# IMMINGHAM EASTERN RO-RO TERMINAL

Appendix 1 to Proposed Changes Notification Report -  
Environmental Statement Addendum  
Document Reference: 10.3.3

October 2023

Appendix 1 to Proposed Changes Notification Report -  
Environmental Statement Addendum

Figure 2.2. General Arrangement Plan showing Proposed Changes

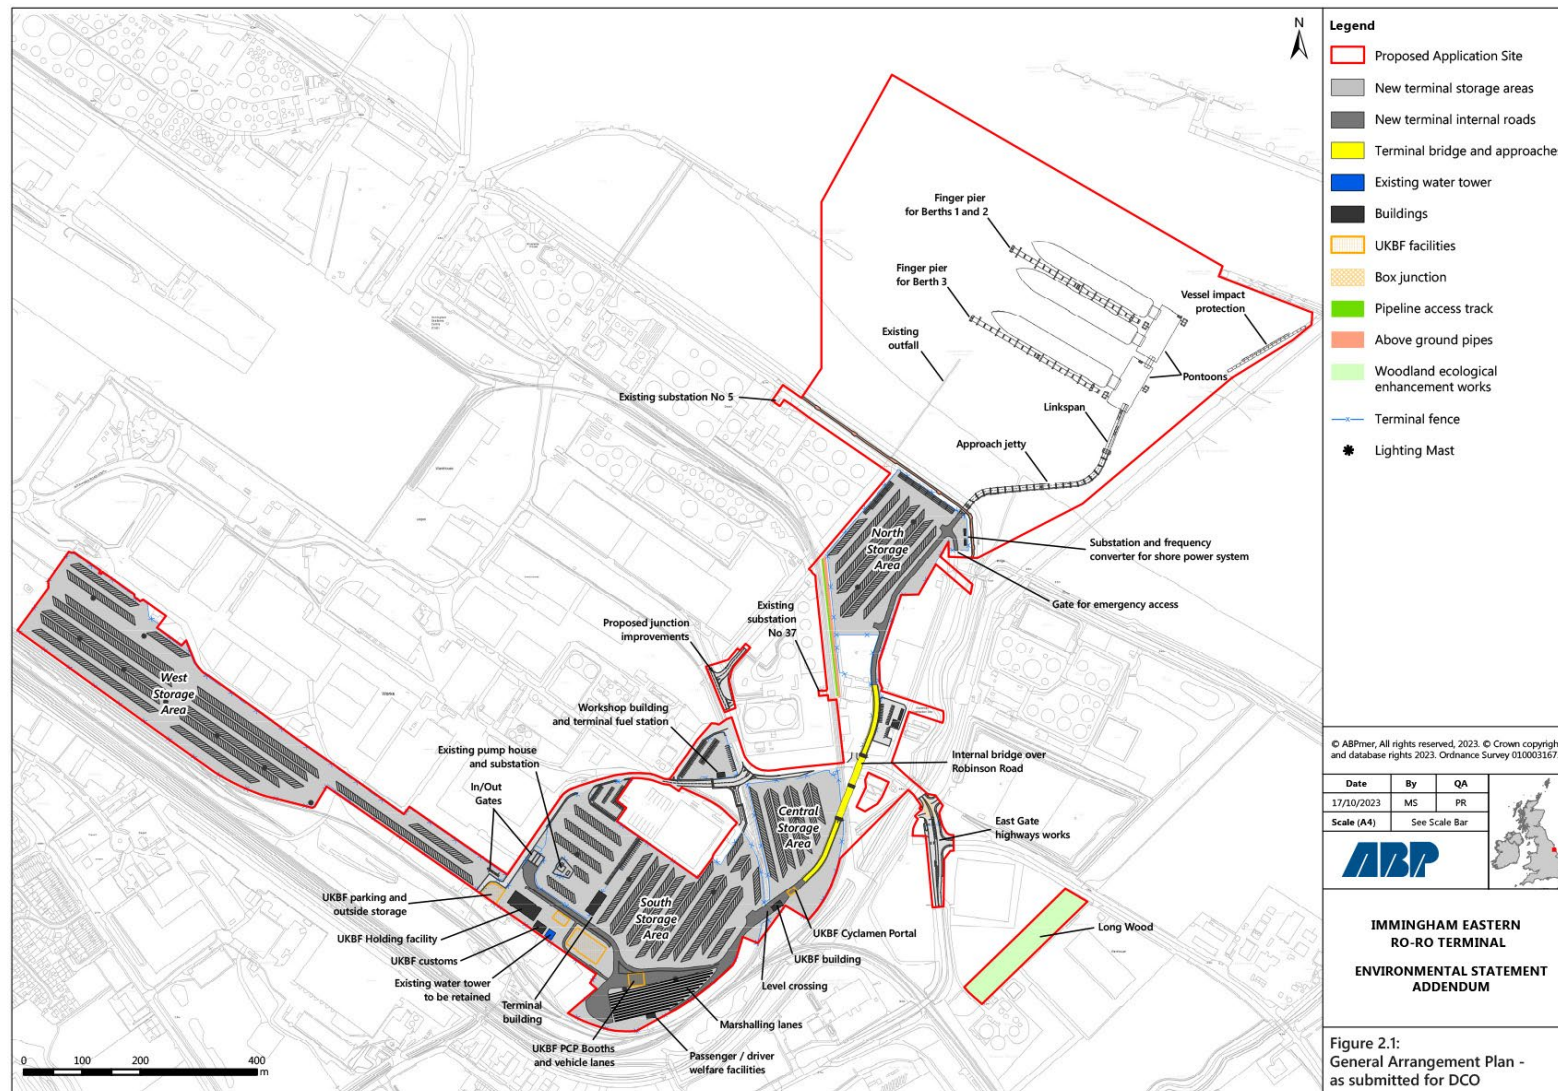
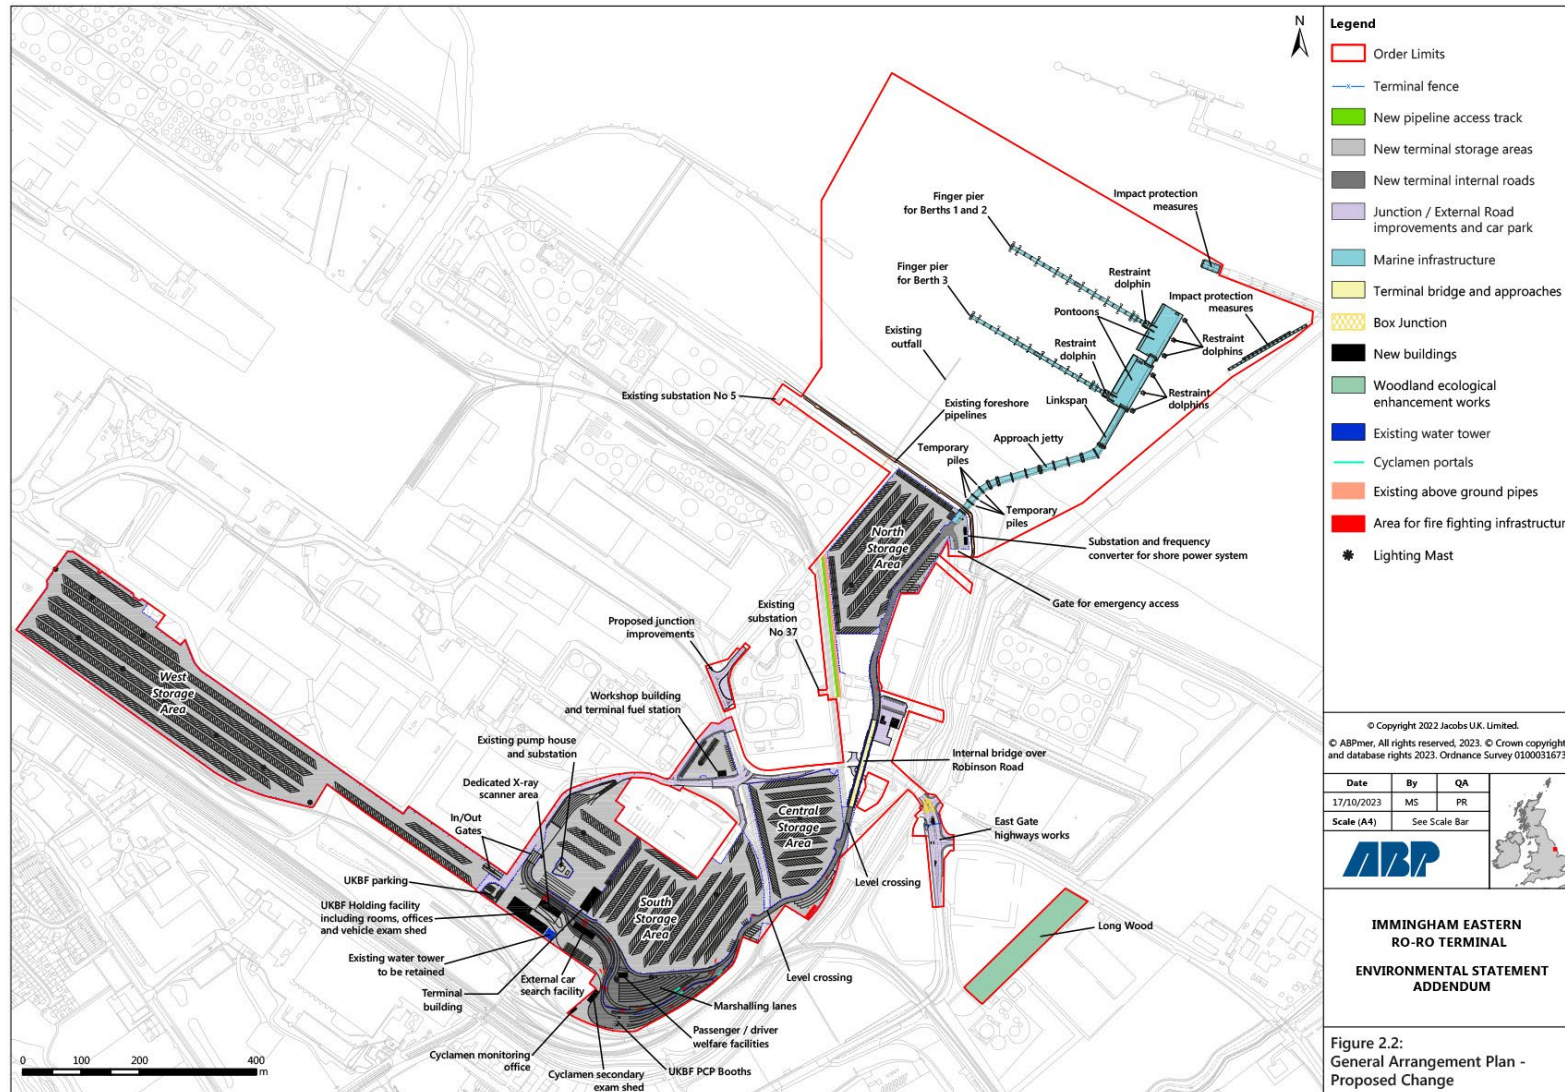
2.1.3 For ease of reference, Figure 2.1 shows the General Arrangement Plan as submitted for the DCO application. Figure 2.2 then shows the General Arrangement Plan with the Proposed Changes.

Figure 2.3. Proposed Change relating to marine infrastructure (Proposed Change 1 and Proposed Change 4)

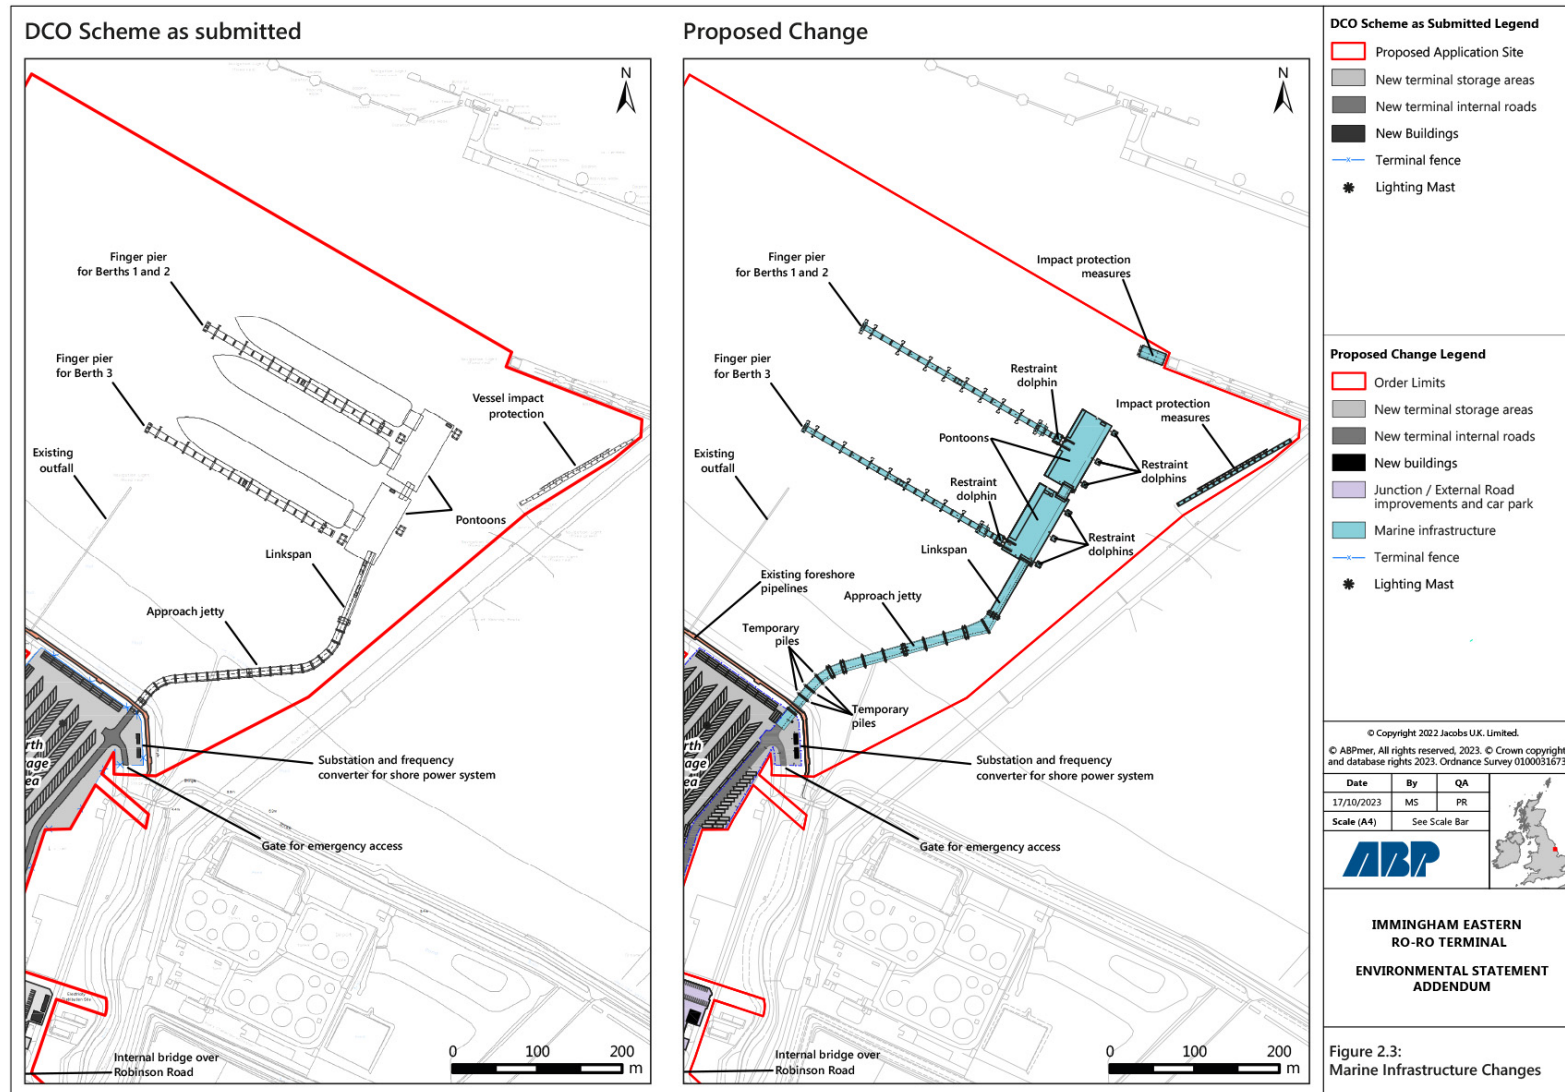
- 2.2.3 As part of the Proposed Changes, the approach jetty alignment has been straightened which moves the approach jetty away from Immingham Oil Terminal (IOT) marine infrastructure whilst still accommodating a suitable swept path for vehicular movement. A comparison of the alignments is shown in Figure 2.3.

- 2.2.4 The approach jetty itself will now be a maximum of 250 m in length, 12.5 m in width (though wider, up to 13 m, at the positions of the piles and up to 17 m at last set of piles before the linkspan (this to accommodate the swept path of HGVs)), and 13.5 m in height above chart datum (CD). The deck will be supported by a maximum of 46 piles. The abutment structure on the seaward side of the defences will also be repositioned and reduced from six piles to three (this is described in more detail below at paragraph 2.2.8). Six piles will be used for the linkspan bank seat (as per the originally proposed scheme). Therefore, the maximum number of piles for the approach jetty now totals 55. It should also be noted that, whilst the maximum diameter of piles for the approach jetty and finger piers remains 1,422 mm, a number of piles have also been reduced in diameter.

- 2.5.2 It is proposed that the impact protection measures would consist of an impact protection structure at the end of the IOT finger pier (see Figure 2.3). This will be in addition to the linear impact protection structure as originally described in paragraph 2.3.18 to 2.3.20 in Chapter 2 of the ES [APP-038] and included in Works Order no. 3 [APP-007]. The only change to the existing linear impact protection structure is that the pile diameter is proposed to be increased from 1,422 mm to 1,520 mm.

Figure 2.4. Proposed Change 2: Realignment and shortening of the IERRT internal bridge

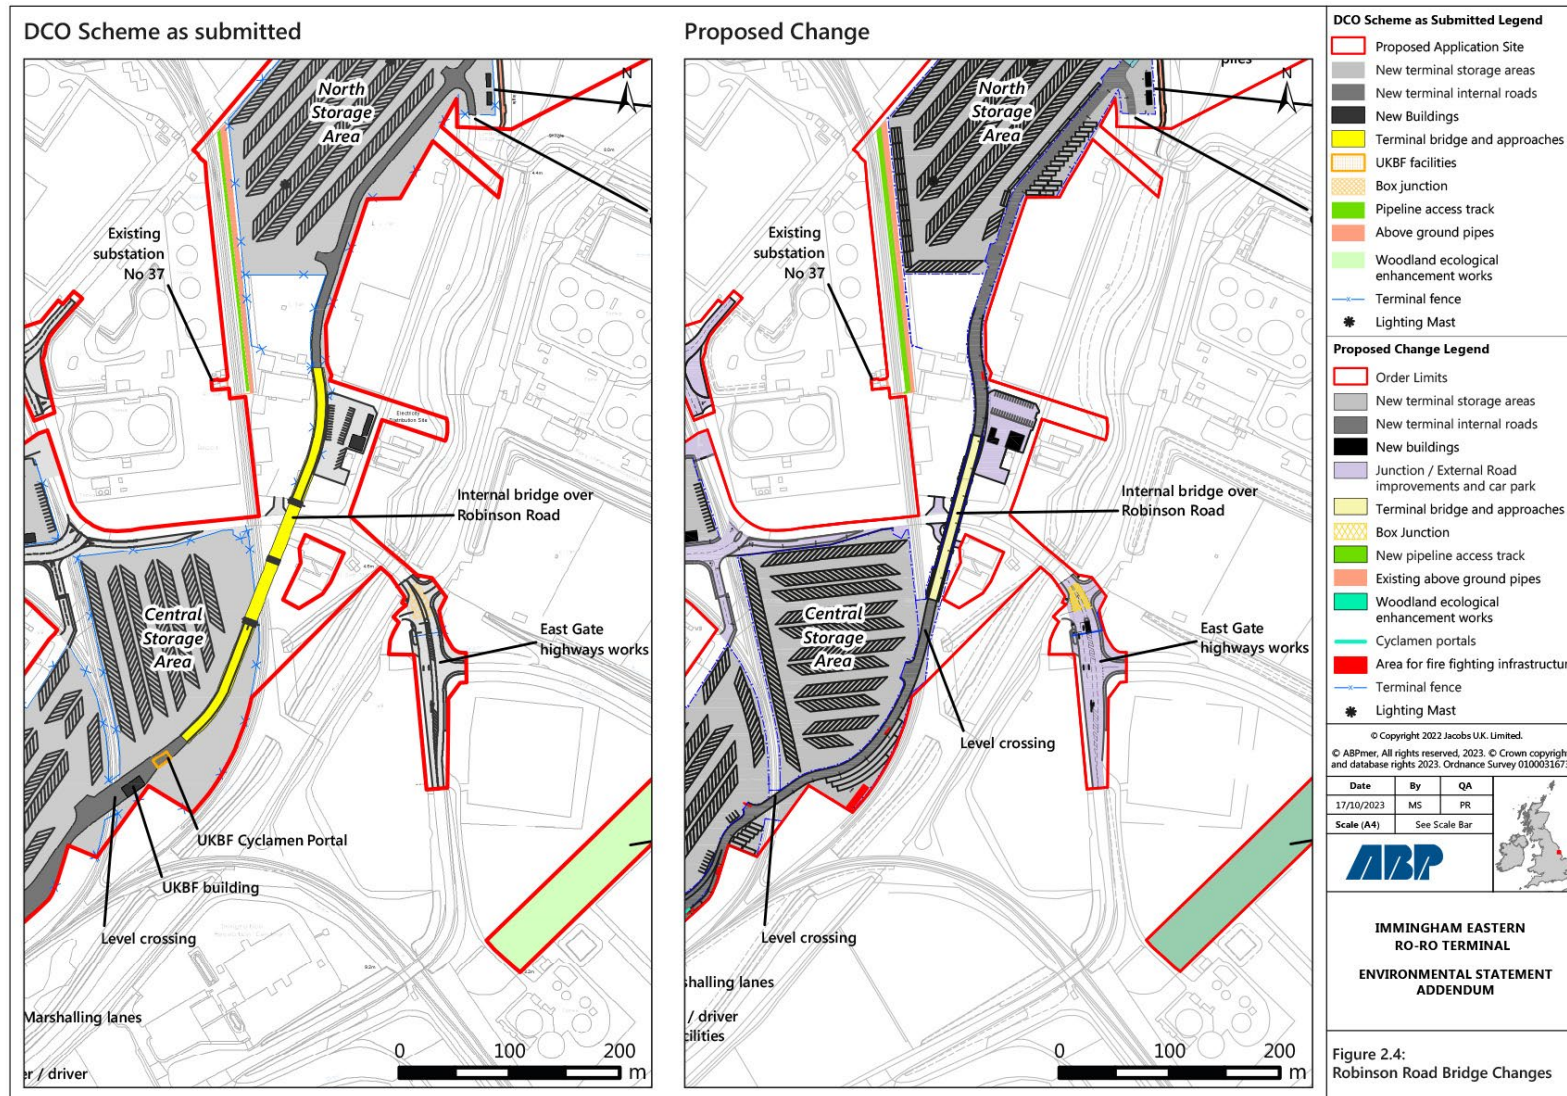
- 2.3.2 As part of the changes to the DCO application, it is proposed that this design is amended so that the bridge spans Robinson Road but not the ABP controlled railway spur line (Figure 2.4). The railway would instead be crossed via an at-grade (i.e., ground level) level crossing. The proposed bridge deck length has been shortened to 86 m with a maximum height of 11 m above the ground. The maximum width of the bridge would not increase.

- 2.3.3 It is necessary to make a minor amendment to the alignment of the southern end of the bridge, moving the alignment eastwards requiring an amendment to the limit of deviation shown in Works Order no 7 [APP-007]. This is to ensure there is sufficient space for the bridge to cross the railway line at ground level.

Figure 2.5. Proposed Change 3: Rearrangement of the UK Border Force facilities

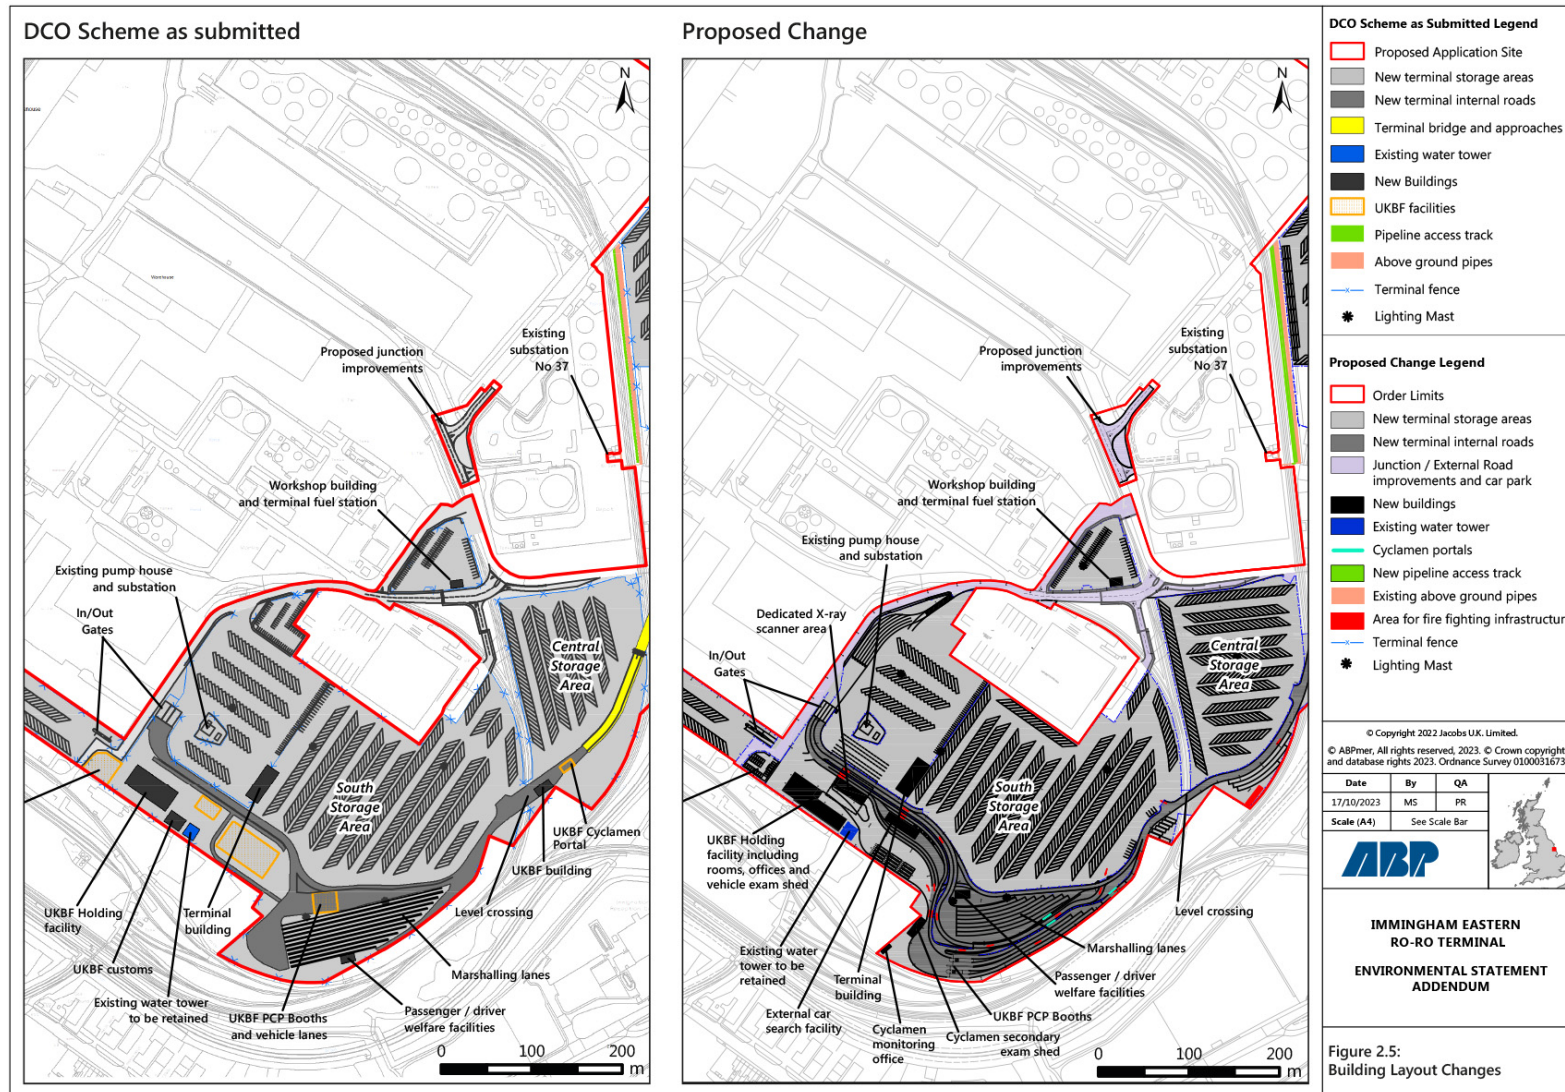
- **Cyclamen Search Building:** A minor relocation of the building is proposed within the limits of deviation with no change in size;
  - **Cyclamen Portal:** A minor relocation of the portal closer to the UKBF buildings is proposed within the limits of deviation to improve operational efficiency with no change in size; and

- **Passport Control Booth:** A minor relocation of the building is proposed within the limits of deviation with no change in size.
- 2.4.4 In consultation with UKBF, changes are also proposed to the operational layout. The inbound road and associated passport control booth (noted above) have been moved to the southern boundary requiring the shift of the marshalling lanes to move slightly northwards. Additionally, a new unaccompanied lane has been created between the passport control booth and the marshalling lanes to allow continues transit of unaccompanied freight and improve customs operations.

- 2.4.5 These changes are shown in Figure 2.5.
